WorldSID small female SBL C

WorldSID small female Kit Prototype conversion to Revision1 (kit A to B) (APROSYS Rev1 dummies)					
Next Assembly	Qty	PN	Level 2	Desc	Replacement for Part in SBL A
W5-3000	5	3700-00		2D ITRACC Assembly with 12pin circular connector	3690-00 (ref); W5-3331
W5-3000	6	W5-3272		Inner Rib, Assembly, Thorax	W5-3283
W5-3000	2	W5-3270		Inner Rib Assembly, Shoulder	W5-3291
W5-3000	4	W5-3271		Inner Rib Assembly, Abdomen	W5-3271
W5-3000	1	W5-3156		ACCEL MOUNT, SHOULDER ENDEVCO 7264B	new part
W5-3000	5	W5-3351		W5 RIB COUPLER	W5-3304, W5-3305
W5-3000	1	W5-3352		W5 RIB COUPLER	W5-3304
W5-4000	5	W5-4040		ACCELEROMETER MOUNT, LINEAR TRIAXIAL, ENDEVCO 7264B	new part
W5-4000	1	W5-4041		MOUNTING WEDGE, LUMBAR WORLD SID 5TH	w5-4037
W5-4000	1	W5-4042-A		CLAMPING PLATE, UPPER LUMBAR	w5-4032
W5-5000	2	W5-5211		LOWER LEG WELDMENT	180-5509
W5-6000	2	W5-6106		ARM ASS'Y	w5-6000
w5-0000?	1	W5-8210-B		Dummy suit with updated sleeves (without foam arm pit)	W5-8210

2D-IR-Tracc

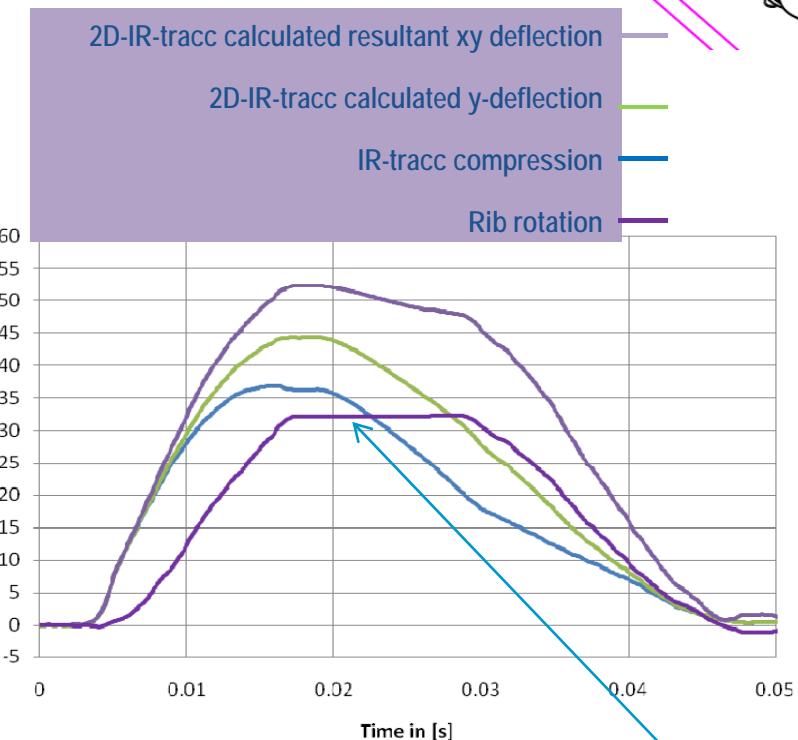
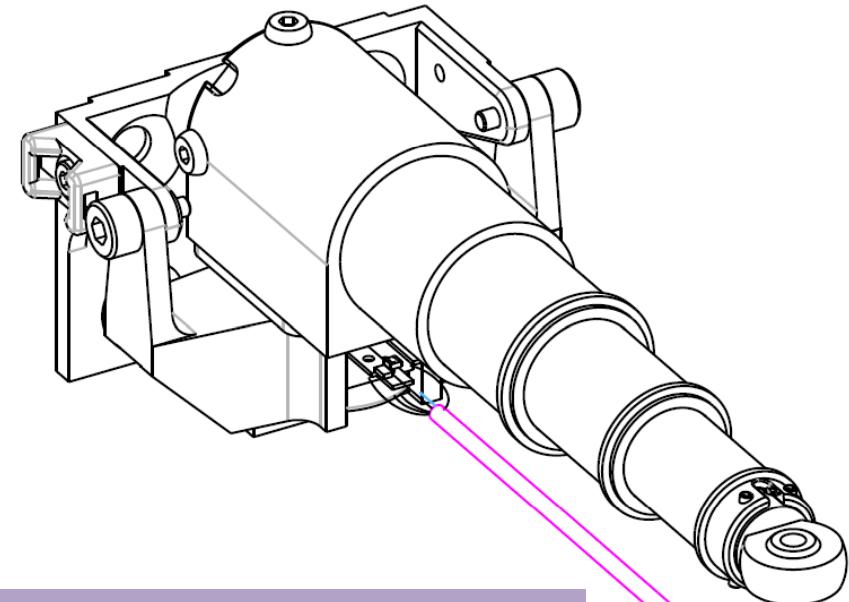
- Part IF-371
- Increased Z-axis ROM $\pm 45^\circ$
 - 6.0m/s pendulum about 40° rotation
- More durable small end
 - Wire and ball joint fixation
- Thorax mass optimised for 2D-IR-Tracc

Result first prototype 2D-IR-Tracc rotation flat top at 32°

Dummy Lifting Bracket

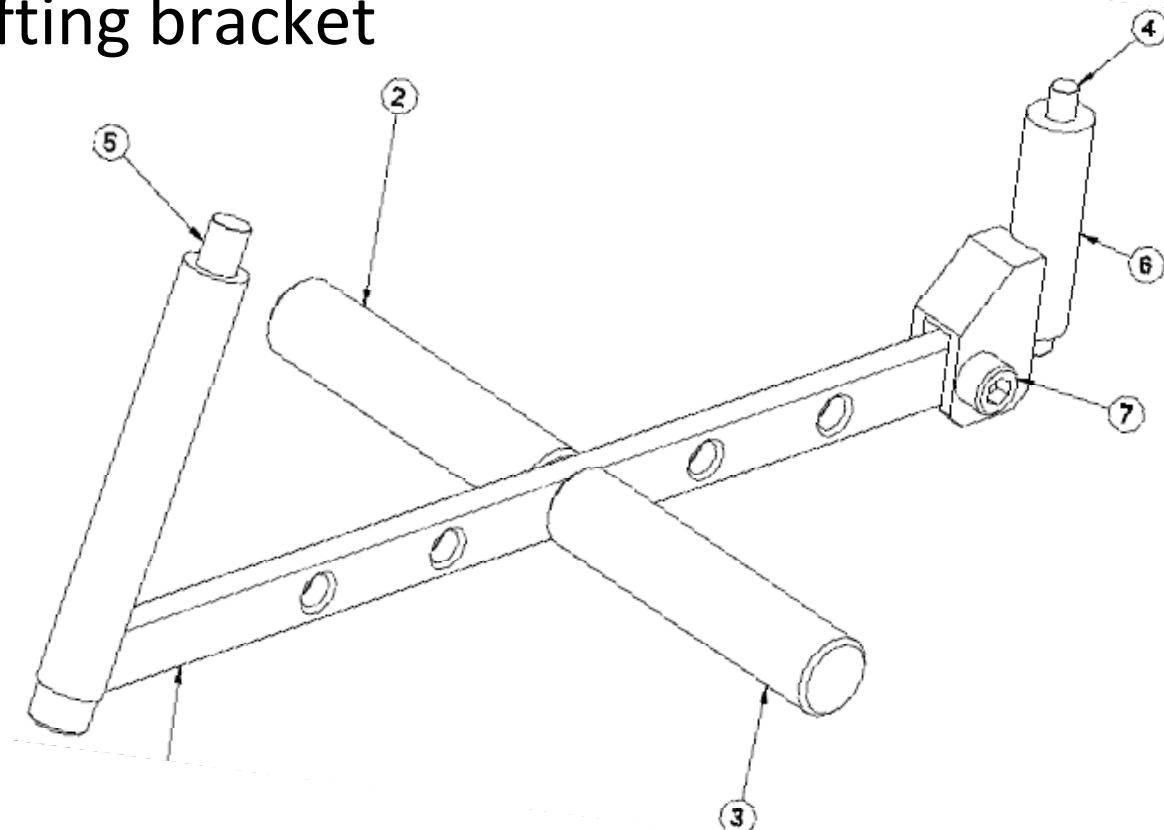
- Old design difficult aligning 2 screws in thorax & pelvis
- Handling improvement
- New ‘split’ design allows first threading screws separately, then mating the lifting bracket
- W5-8400-B

Lower lumbar mounting bracket

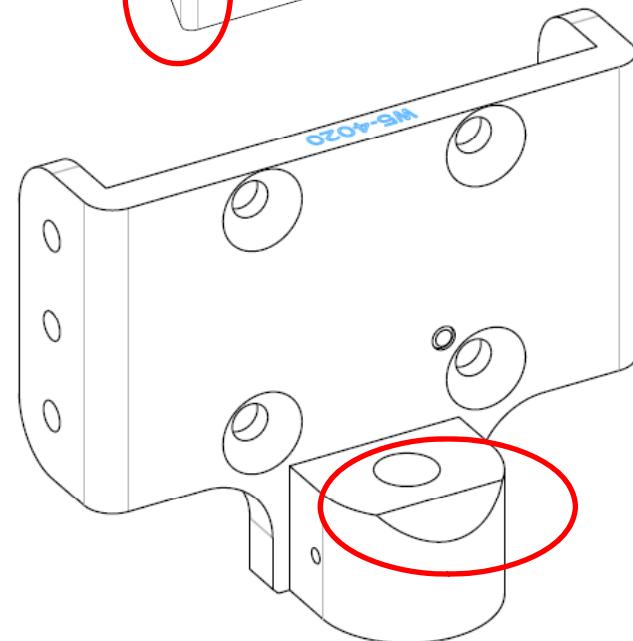
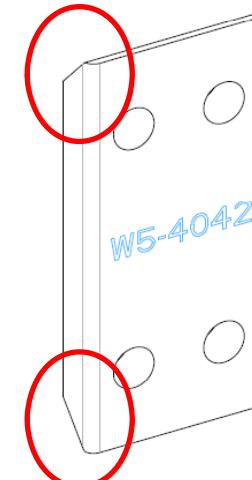
- ▶ Add chamfer on W5-4020-D
- ▶ Add chamfer on W5-4042-B
- ▶ Modification of existing parts
- ▶ Reduce change at metal-metal contact

Pelvis earth leads part W5-9000

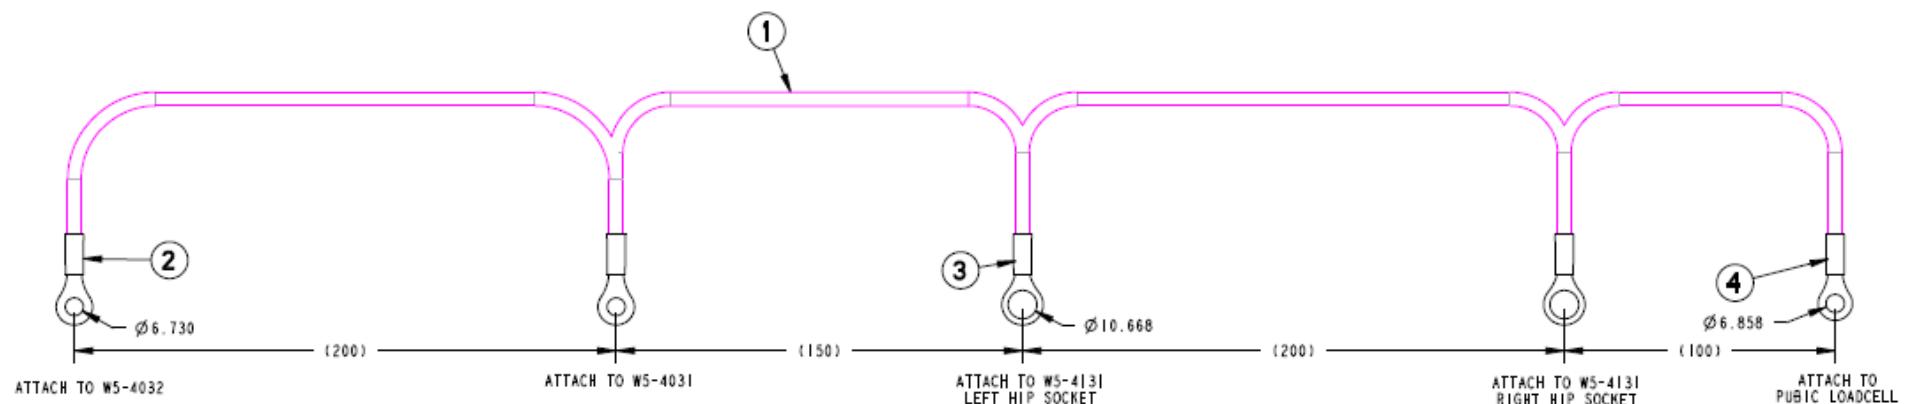
- ▶ Earthing between legs, pubic, sacrum and thorax
- ▶ Wire remains in the pelvis even when split at the thorax
- ▶ Thorax earth is restored when lumbar bracket assembled to thorax

DAS thigh structural replacement

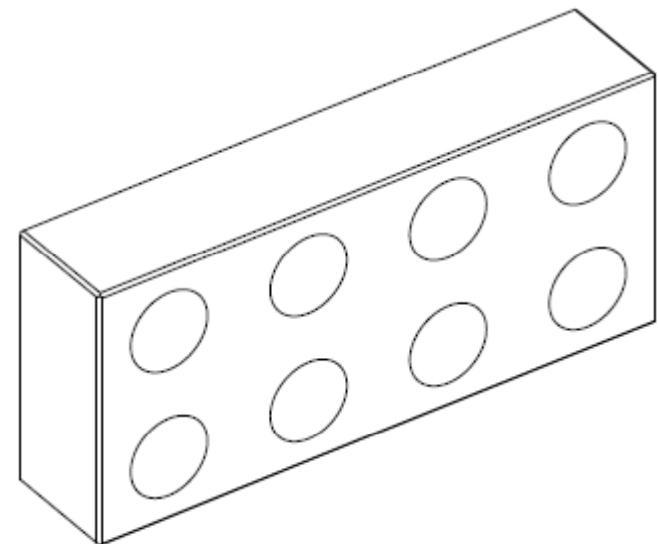
- ▶ DAS structural replacement did not fit the thigh cavity well
- ▶ New part W5-5021-B

Issue current WS50M ankle design

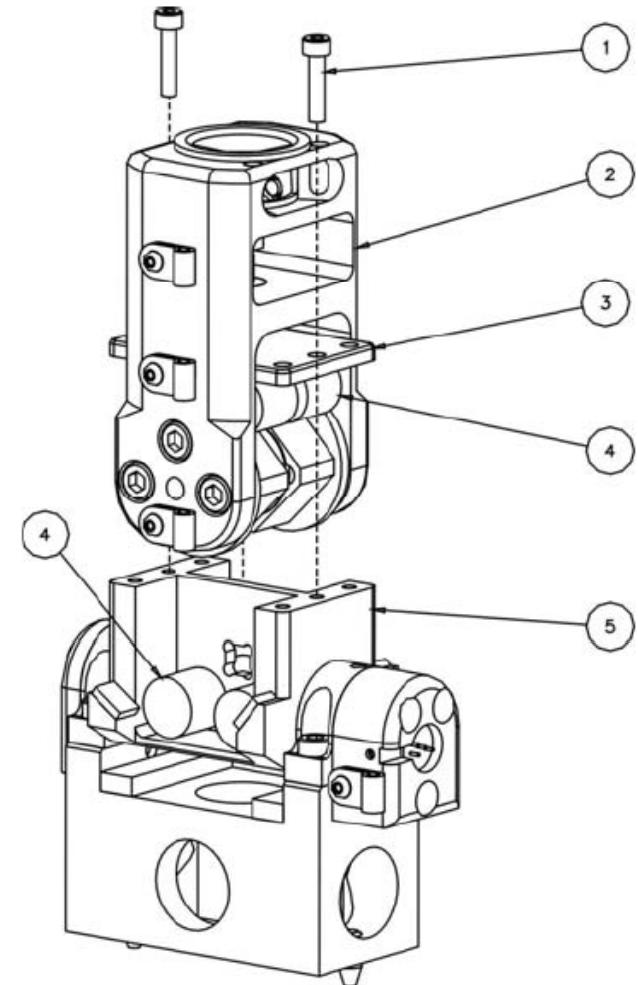
- ▶ WorldSID adjustment of foot position to vehicle interior is difficult
- ▶ Increasing moment of ankle joint from mid position
- ▶ Desire friction setting in mid position and free range for adjustment
- ▶ WorldSID 50M has highest priority
- ▶ In Tokyo it was decided to first try concept in the 5F WorldSID

Lower leg, ankle & foot

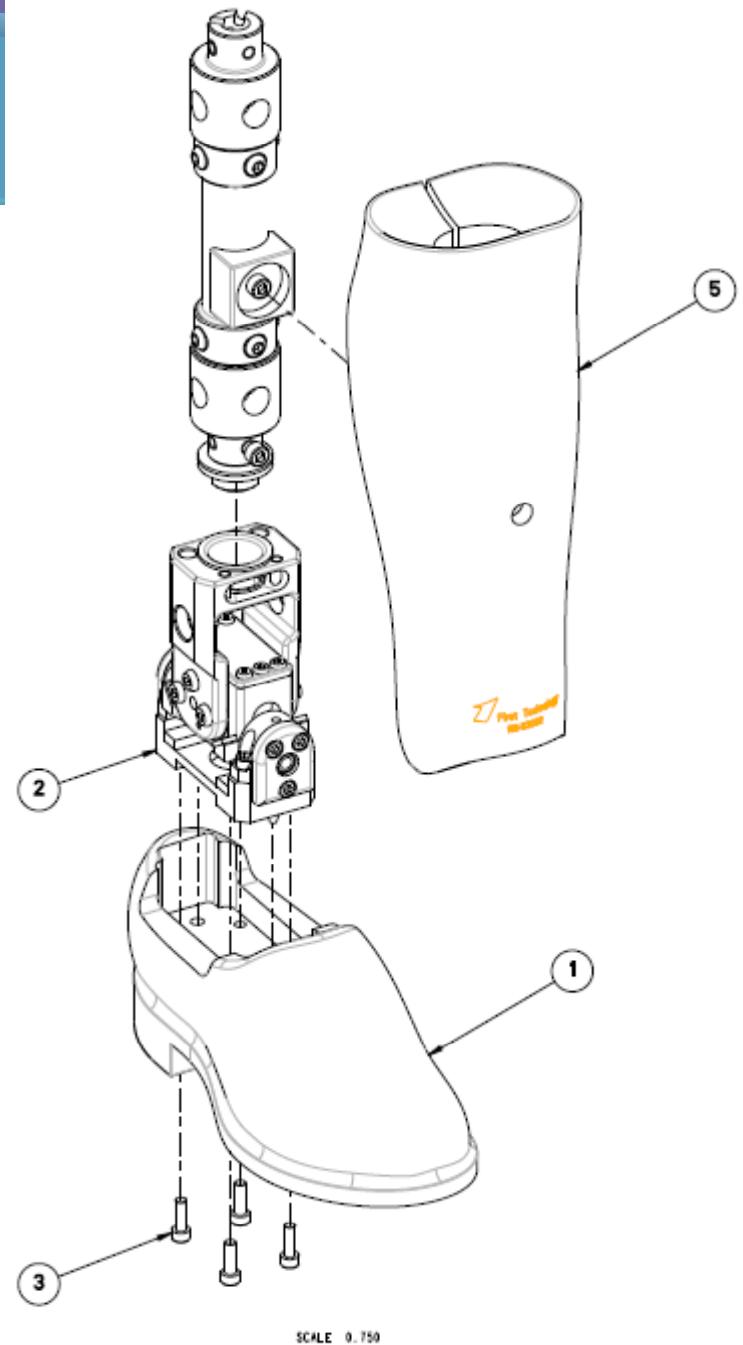
- ▶ WorldSID 50M style
- ▶ New aluminium tibia load cell
- ▶ Molded foot and shoe
- ▶ Parts W5-5455 and 5456
- ▶ Ankle and lower leg LH&RH identical
- ▶ Shoe is handed left and right
- ▶ Redesign ankle flexion joint just started
 - Adjustable friction
 - address foot positioning started

Concept

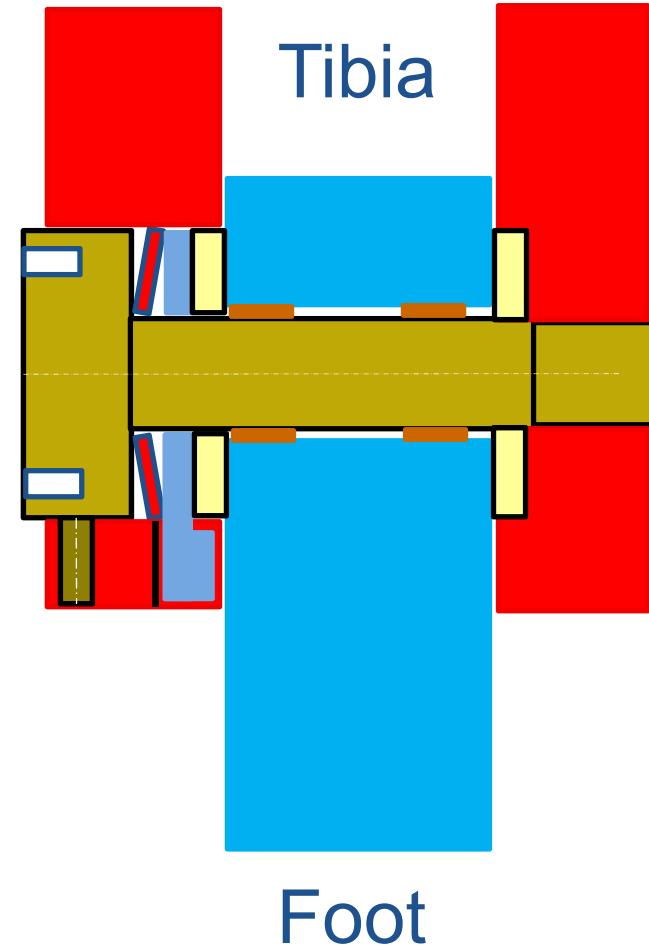
- ▶ Shoulder bolt
- ▶ Adjust compression on disc spring
- ▶ Nylon friction rings
- ▶ Set screw to maintain adjustment
- ▶ Friction adjustable between 0 and 10Nm
